2027-2028 T&C VSP

Public Consultation Comments

30/06/2025 | Alexandre Nève

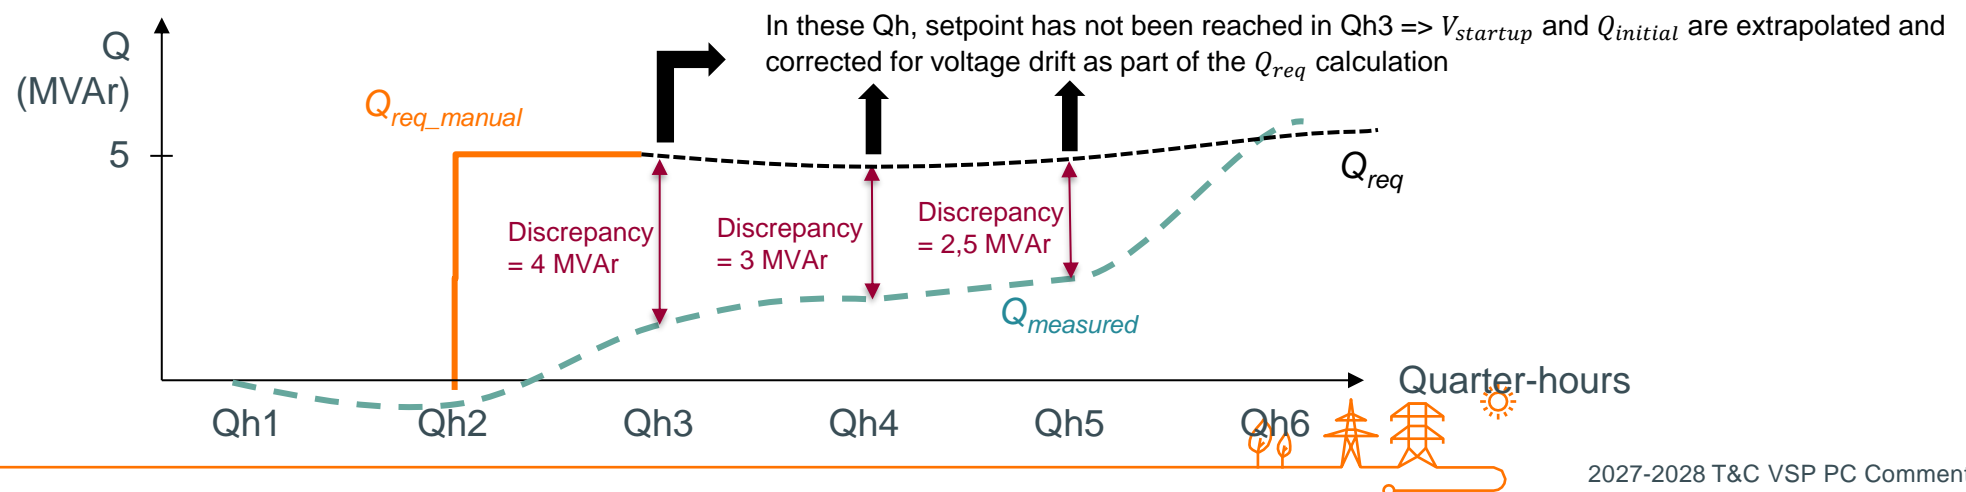
- **Comment:** Cumulated remuneration reduction is disproportionate or proposed design introduces an inherent control error. Return to the current remuneration reduction formula or to an alternative one-time reduction formula is requested.

- Elia will add example cases with setpoints not reached in Annex 2 and Annex 3. Elia will create a new Figure to illustrate the case when the setpoint is not reached, with a Curve 2 showing the delivered voltage to reactive power function. The sentence “The Technical Unit restarts the Automatic Control following the curve 1.” will be corrected to refer to this curve 2.

This chart displays Elia's proposal for MVAR unavailabilities determination logic, minimizing VSP efforts.

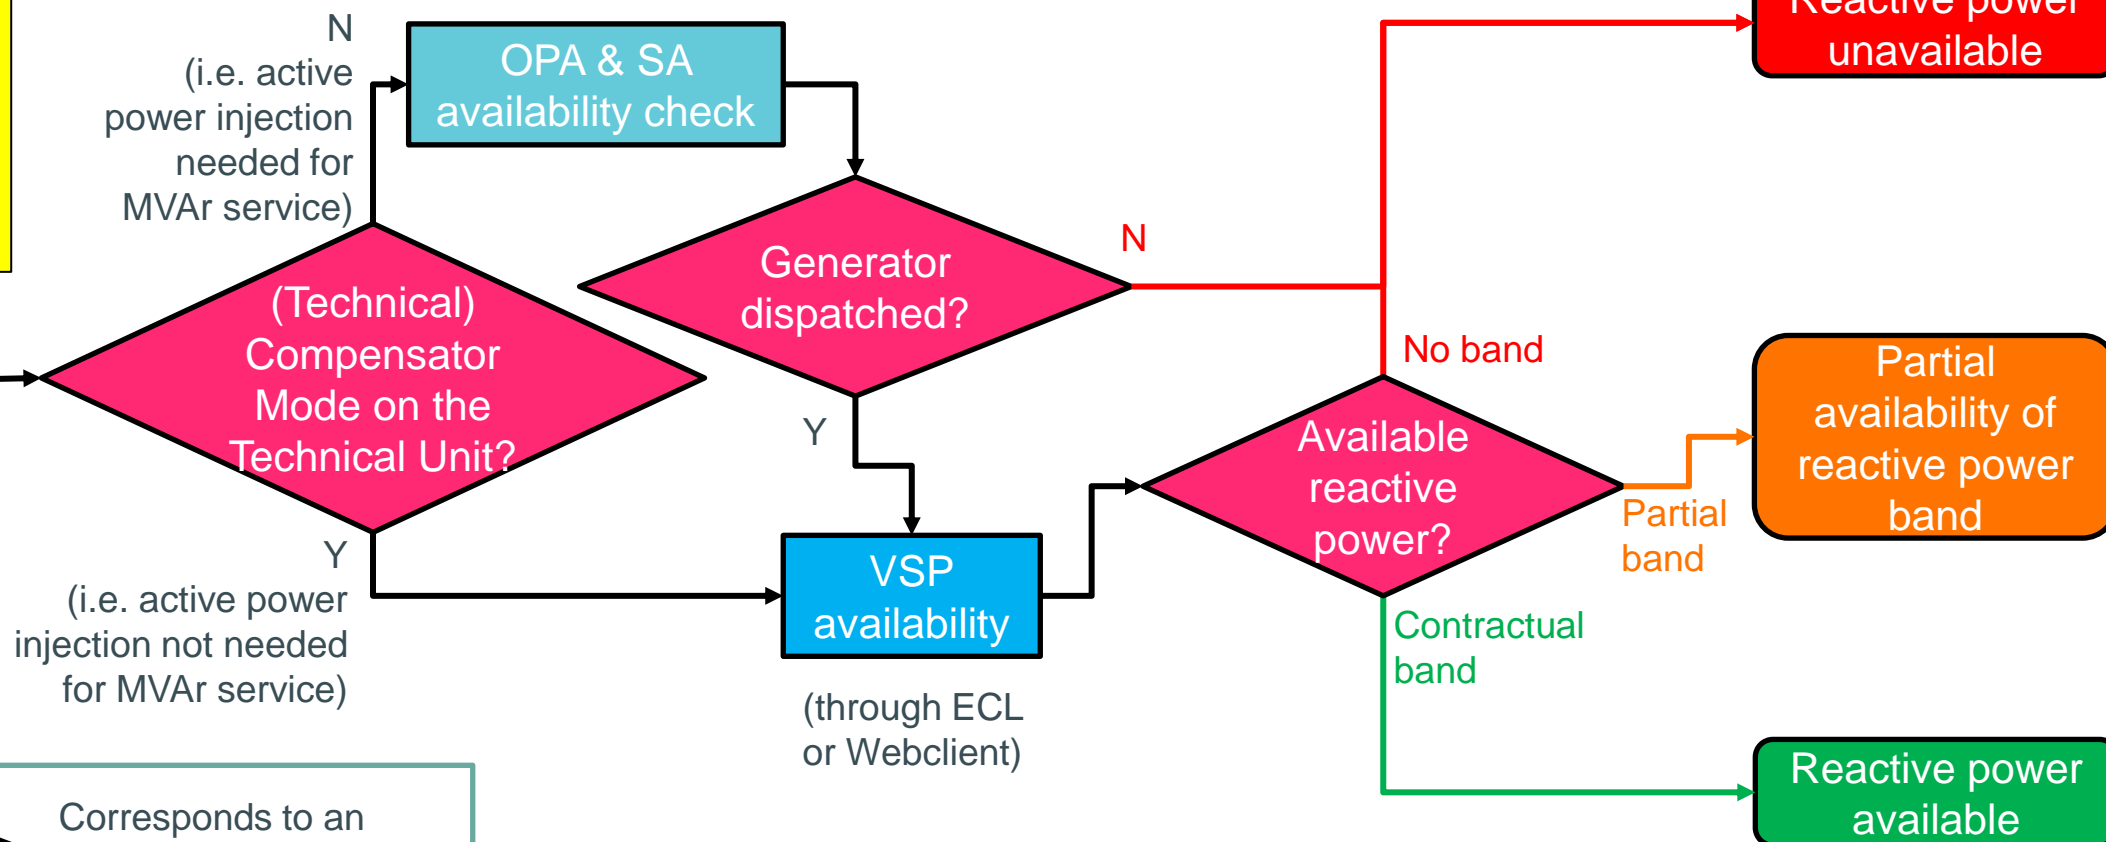
- T&C state that VSP must determine reactive power availabilities. 3 MPs request that Elia determines the reactive power availabilities so VSP do not have to provide them.

- Conclusion: **VSPs must provide reactive power availabilities, Elia cannot rely solely on OPA availabilities.**
 - For TUs unable to provide the Voltage service without active power injection (i.e. conventional generators, some WT), **Elia will determine the future reactive power service actual availability from the combination of the Outage Planning Agent and from the Scheduling Agent schedules to reduce workload for VSPs.**

(The Explanatory Note will be adapted with this explanation and this Figure)

Communication through webclient and ECL

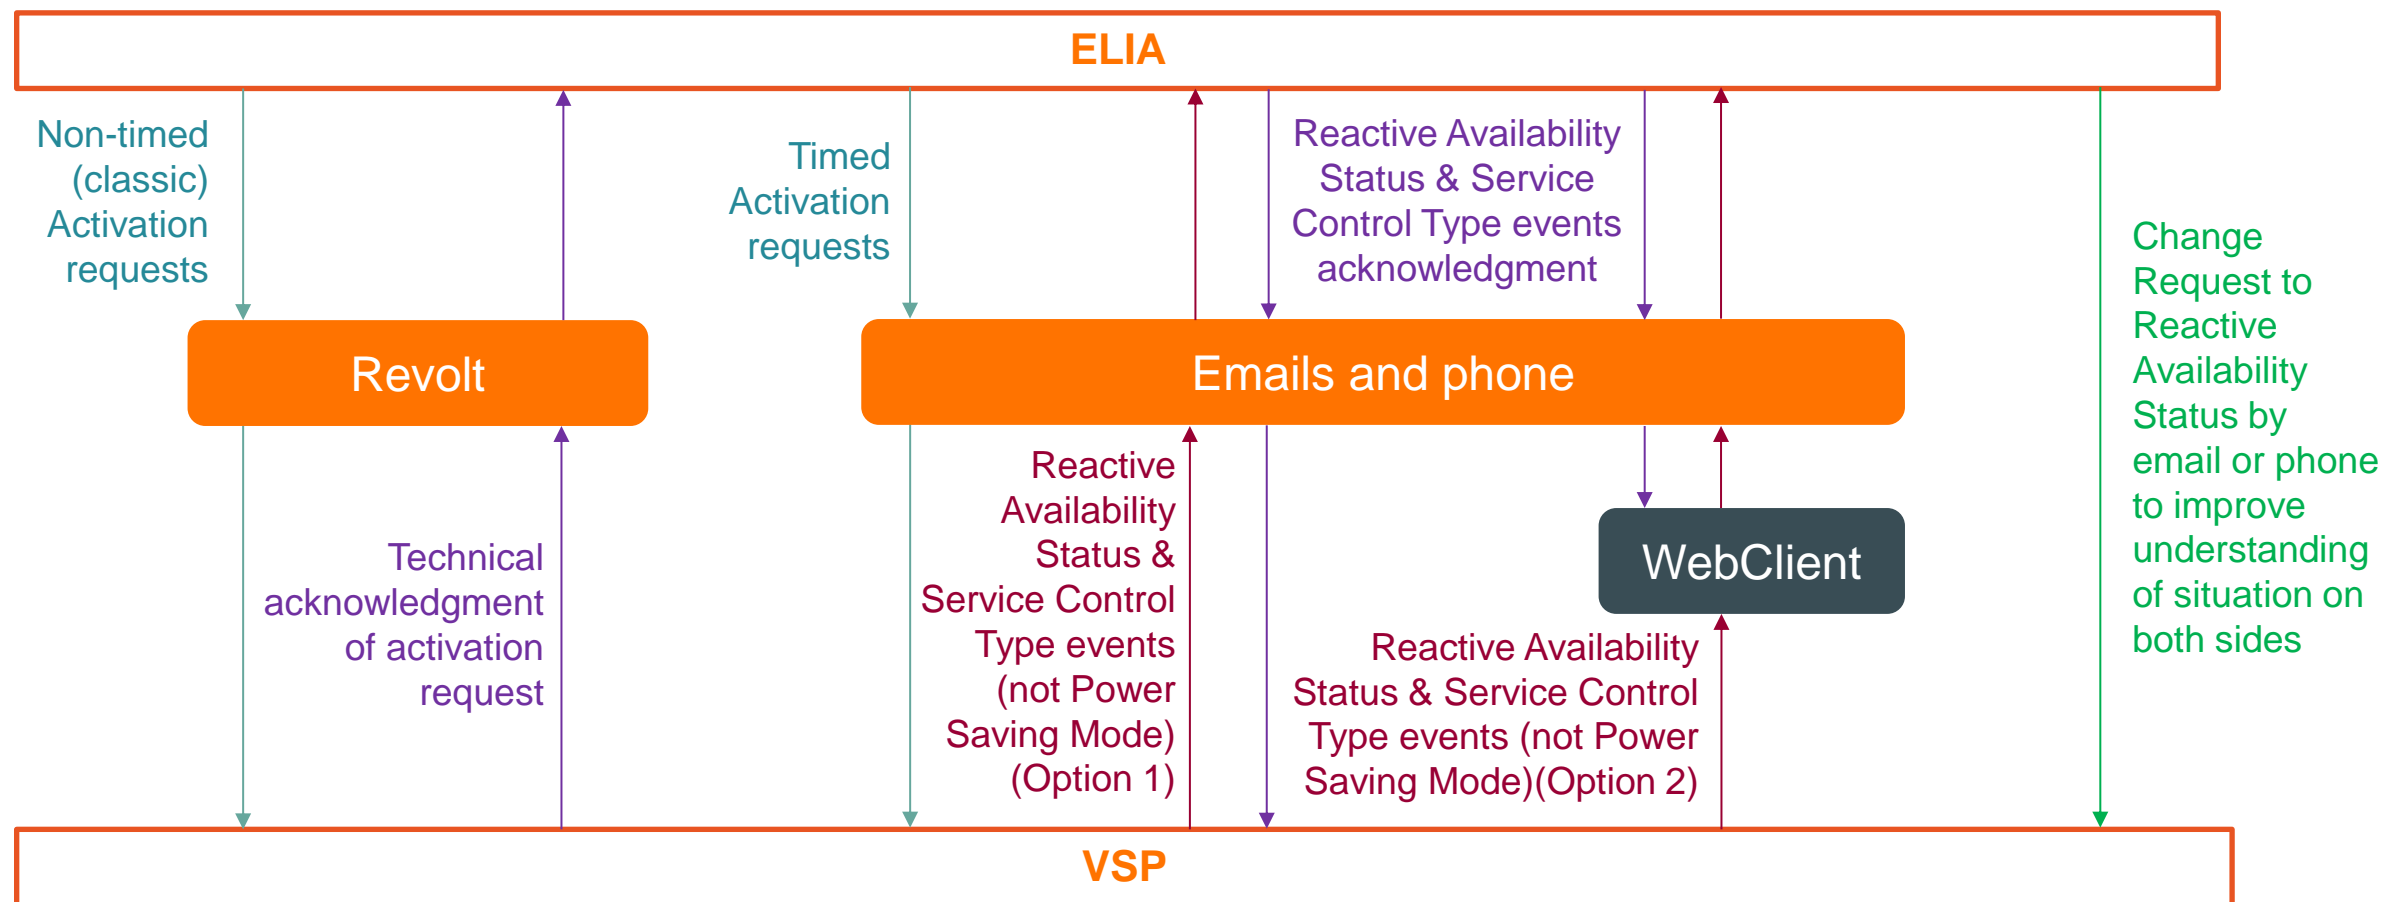
- FEBELIEC comment: “As Elia will develop a webclient in which the VSP can introduce their data manually for all the incoming data (assets unavailabilities and acknowledgment messages), can Elia confirm that the implementation and use of the External Communication Layer is only mandatory for the communication by Elia to the VSP of setpoints, start-up requests and activation end times ?”.

- **Elia's answer:**
 - Elia will [add 2 Figures in Annex 14](#) to illustrate the communication channels (see next 2 slides)
 - Elia will communicate reactive power setpoints, start-up requests and activation with end times through the External Communication Layer.
